2. ACTION ITEM: Recommendation to review and approve the 219 Hillside Drive Mountain Overlay Design Review & Conditional Use Permit applications, as conditioned, and direct staff to return with the findings of fact

**STAFF REPORT
KETCHUM PLANNING AND ZONING COMMISSION
REGULAR MEETING OF JUNE 13, 2023**

The applicant is proposing a new 3,745 square foot three-story single-family residence (the “project”), located at 219 Hillside Drive (the “subject property”). The project contains four bedrooms and an attached two car garage. The subject property is zoned Limited Residential (LR) in the Mountain Overlay District (MOD), and the lot is currently vacant. A rendering of the proposed residence can be seen in Figure 1 below.

Figure 2: Project's Roof

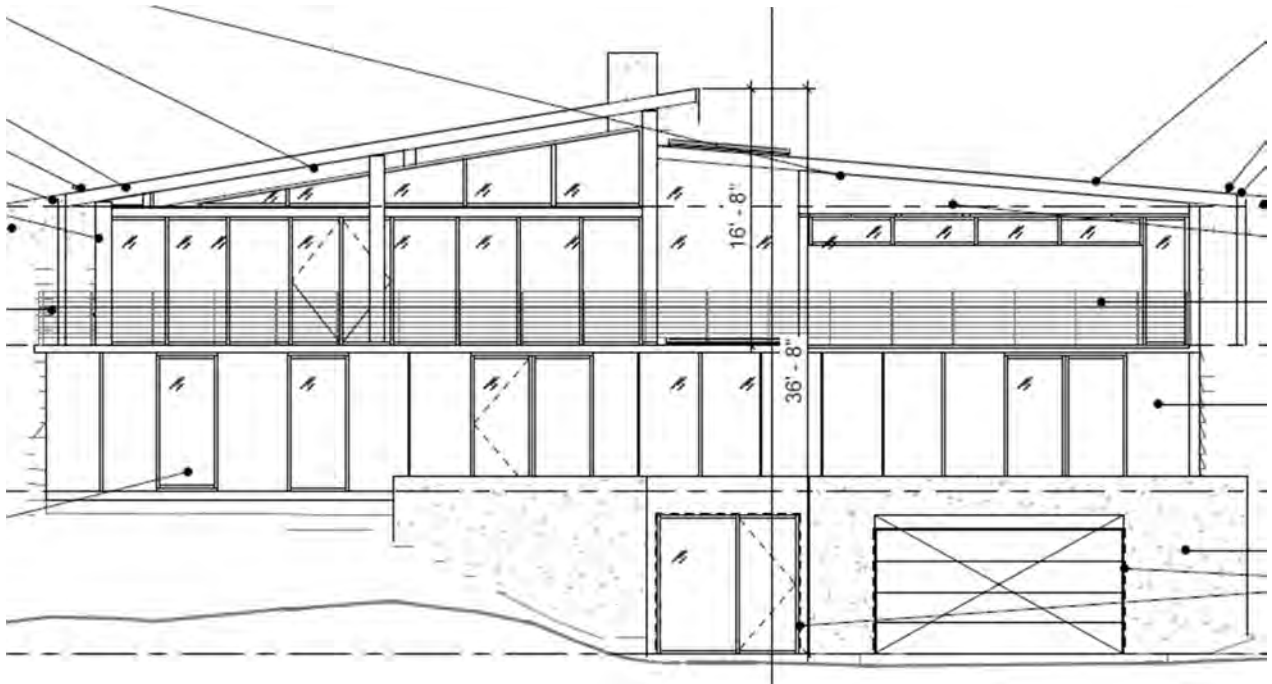
and features a Santa Fe architectural style which has flat roofs with stucco and block forms. The structure to the lookers left is one story in height with pitched roofs and stucco and stone siding. The architectural style of the proposed residence is modern in nature; however, it is complementary of the newer and older residences of the neighborhood as it utilizes wood and steel siding, board formed concrete, large windows, and shed roofs sloped away from each other which presents as a pitched roof. Please see Figure 2 below for details on the proposed roof for the structure. Additionally, pursuant to KMC §17.96.060.F.2 & 5, “The building character shall be clearly defined by the use of architectural features” and “Buildings walls shall provide undulation/relief, thus reducing the appearance of bulk and flatness.” The proposed residence is three stories in height and each floor of the structure is stepped back into the hillside, providing undulation and relief to reduce the appearance of bulk and flatness.

Figure 3: Project’s Front Lot Lines and Front Setback

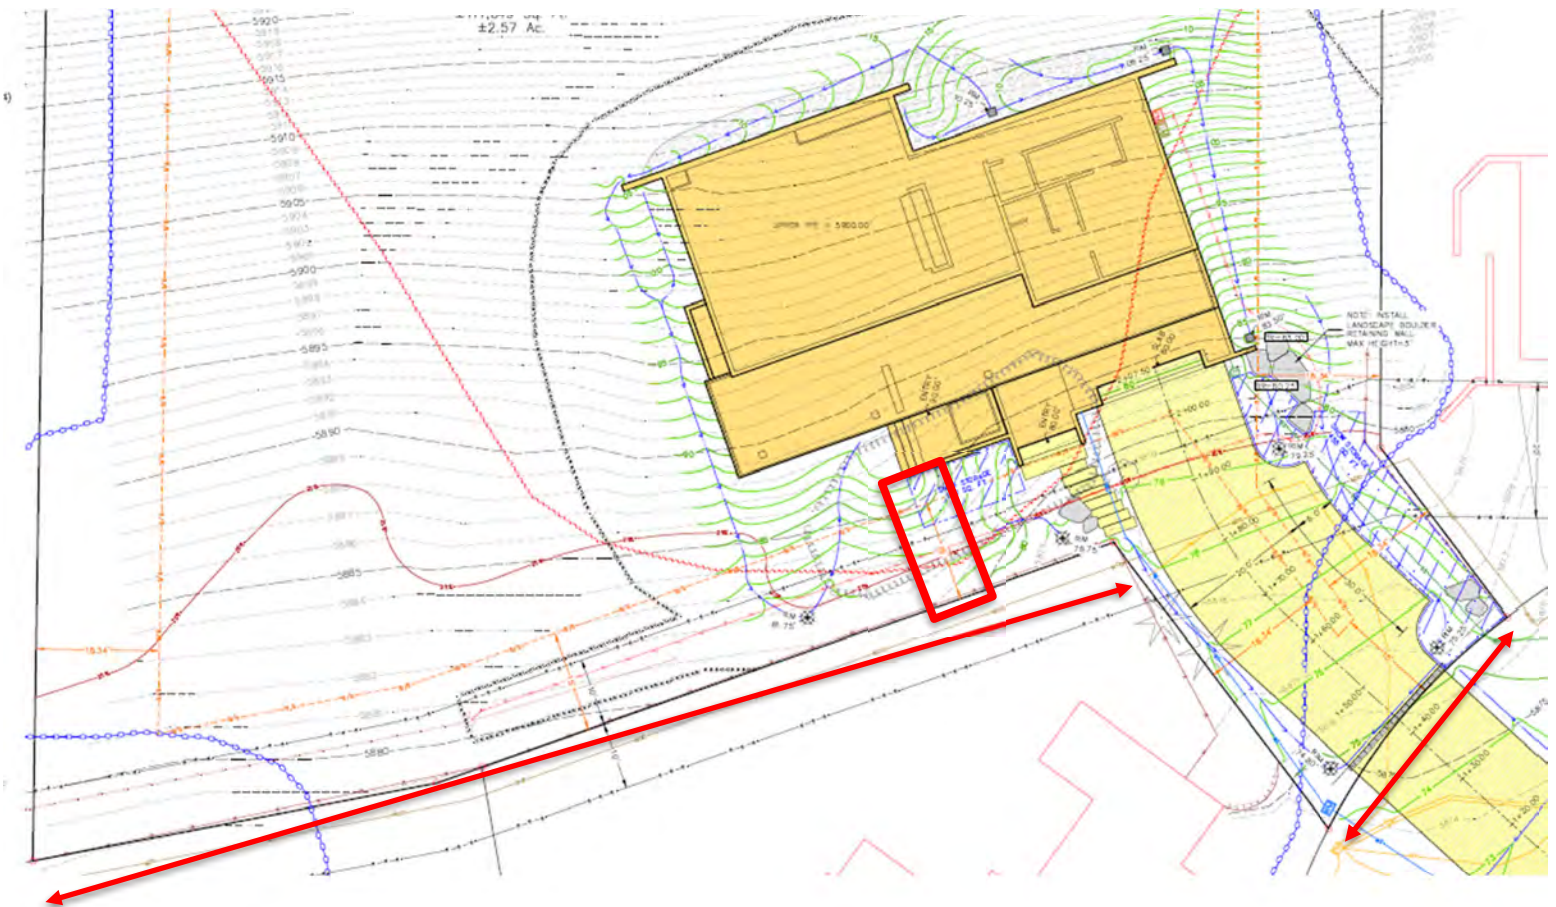
The KMC defines minimum setbacks for the front, side, and rear lot lines for each project. The KMC defines the “lot line, front” as “The property line dividing a lot from a street. On a corner lot, only one street line shall be considered as a front line, and the shorter street frontage shall be considered the front line, unless otherwise determined by the administrator based on the orientation and layout of the lot and surrounding neighborhood.” There are two front lot lines for the subject property. The lot is situated behind two existing single-family homes and is uniquely shaped with a narrow entrance between the two lots to access the subject property. The proposed residence is setback 15 feet from the longer of the two front lot lines, which is setback at the lowest possible elevation. Please see Figure 3 below which outlines the two front lot lines and front yard setback in red.

C1.0

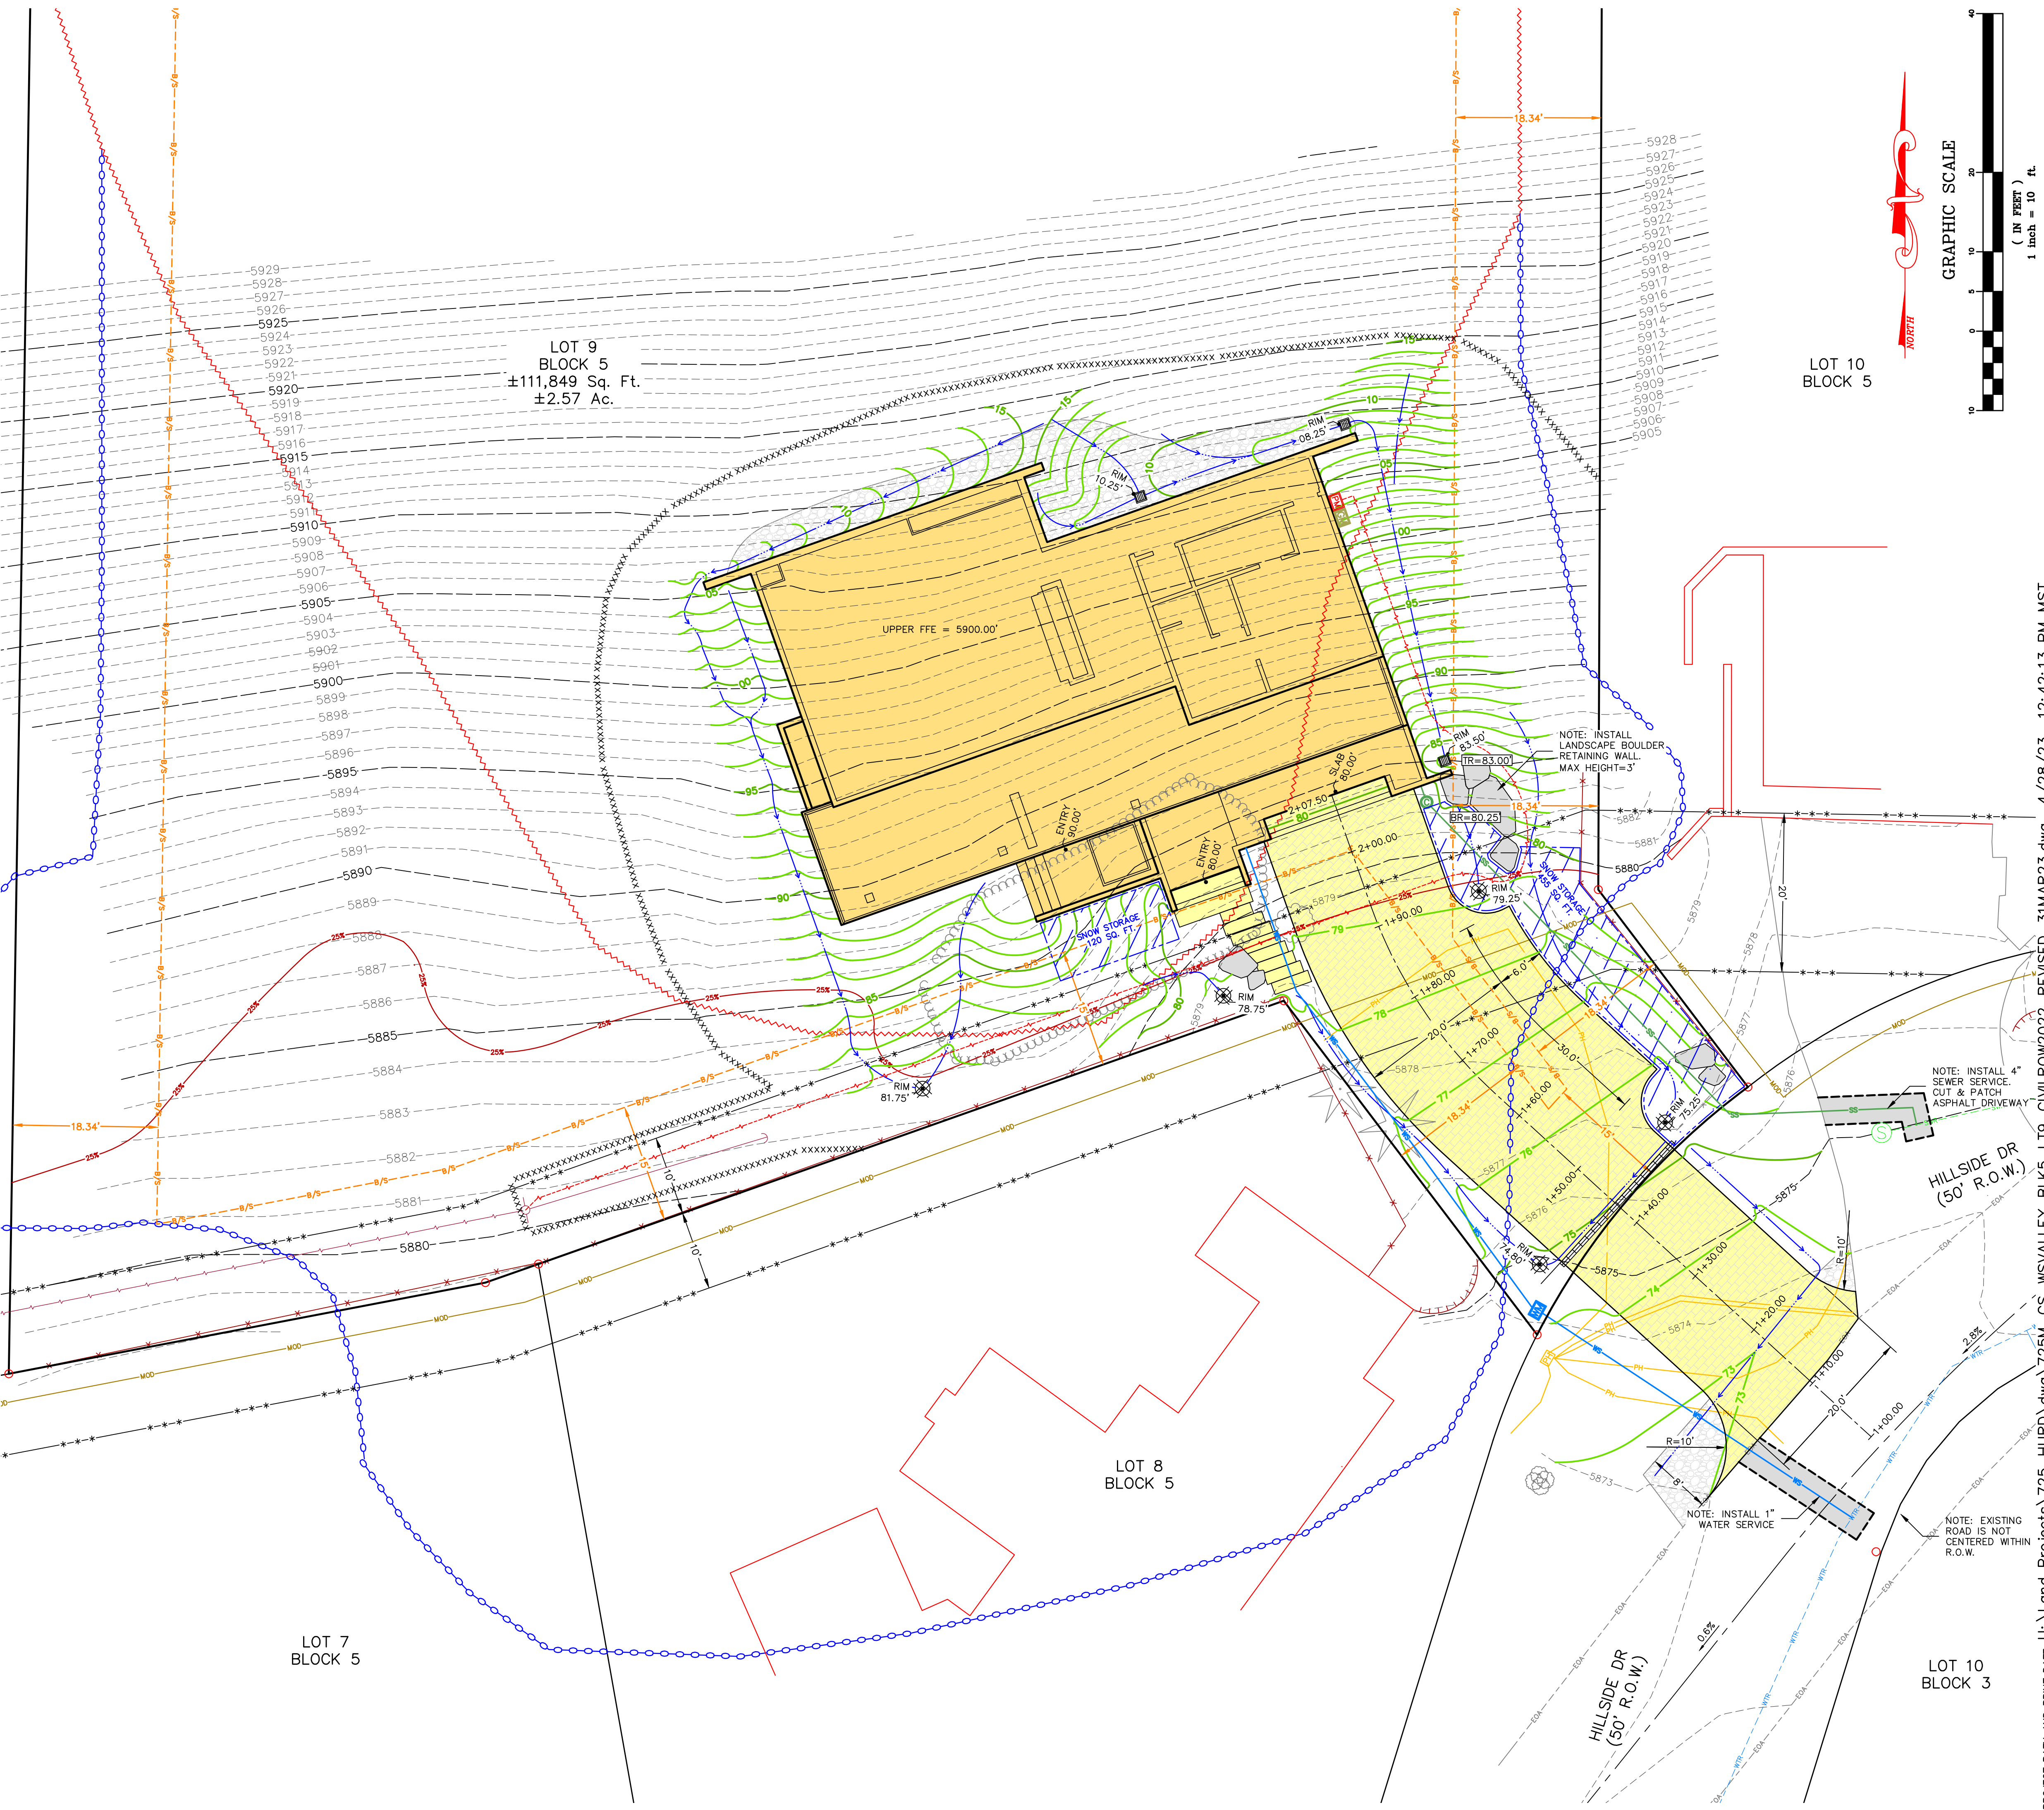
17.96.060.C.1 - Drainage	Conformance
<i>All stormwater shall be retained on site.</i>	YES
Finding: Pursuant to KMC §17.96.060.C.1, all storm water drainage shall be retained on site. Drainage improvements are specified on Sheet C1.0 of the project plans. The drainage improvements include the installation of a trench drain bordering the length of the driveway. A combination of drywells and catch basins will be installed to collect stormwater from the rest of the property. The City Engineer has reviewed the proposed drainage plan and believes

17.96.060.D.2 - Utilities	Conformance
<i>Utilities shall be located underground and utility, power, and communication lines within the development site shall be concealed from public view.</i>	YES
<p>Finding: As shown on Sheet C1.0 of the project plans, the applicant has proposed connecting to the municipal water and sewer systems from existing lines on Hillside Drive. Requirements and specification for the water and sewer connections will be verified, reviewed, and approved by the Utilities Department prior to issuance of a Building Permit for the project.</p>

17.96.060.H.1 – Snow Storage	Conformance
<i>Snow storage areas shall not be less than 30 percent of the improved parking and pedestrian circulation areas.</i>	YES
Finding: Sheets C1.0 & C2.0 show the proposed snow storage areas to include 575 square feet, greater than the required 30% (1,825 * .30 = 547 square feet).

17.96.060.H.2 – Snow Storage	Conformance
<i>Snow storage areas shall be provided on site.</i>	YES
Finding: Sheet C1.0 shows the snow storage areas to be provided are on-site.

17.96.060.H.3 – Snow Storage	Conformance
<i>A designated snow storage area shall not have any dimension less than five feet and shall be a minimum of 25 square feet.</i>	YES
Finding: Sheet C1.0 shows that no snow storage area has dimensions less than five feet.

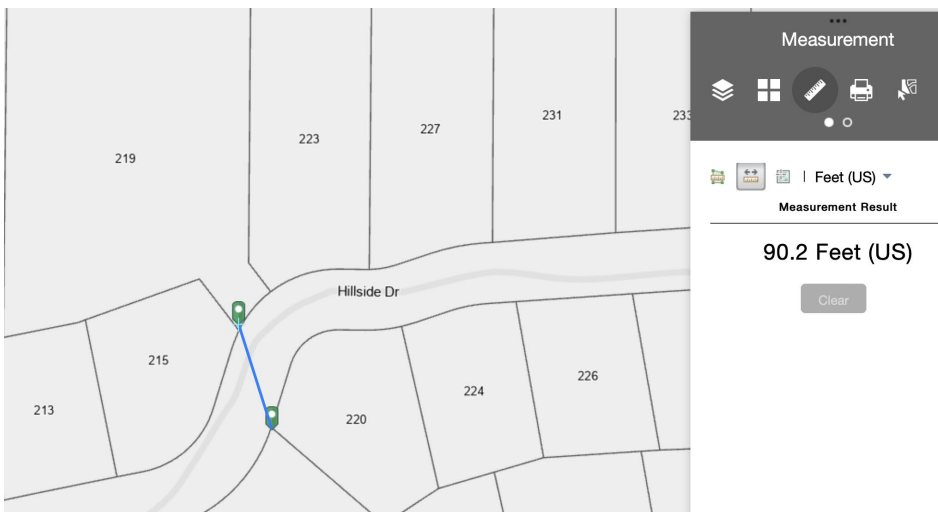
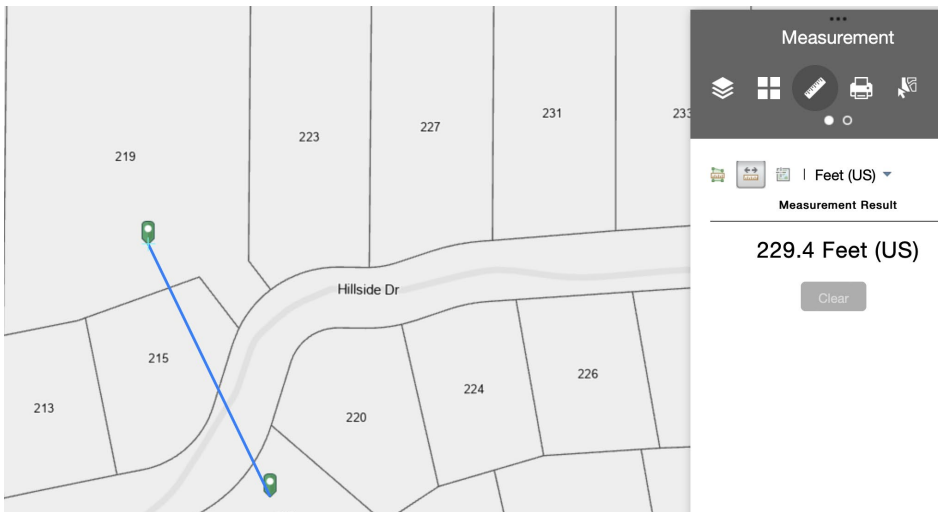
Our property line is +/- **90ft** away from From Millers:

Front door from our house to front door of Millers is +/- **230ft** away:

I have read 172 pages of the Agenda packet. None of the engineering & survey reports, nor the avalanche research specifically addresses or includes the impact this project will have on our property and our adjoining neighbors. Our properties aren't included in any maps or sketches as well. Again, we are 90ft away.
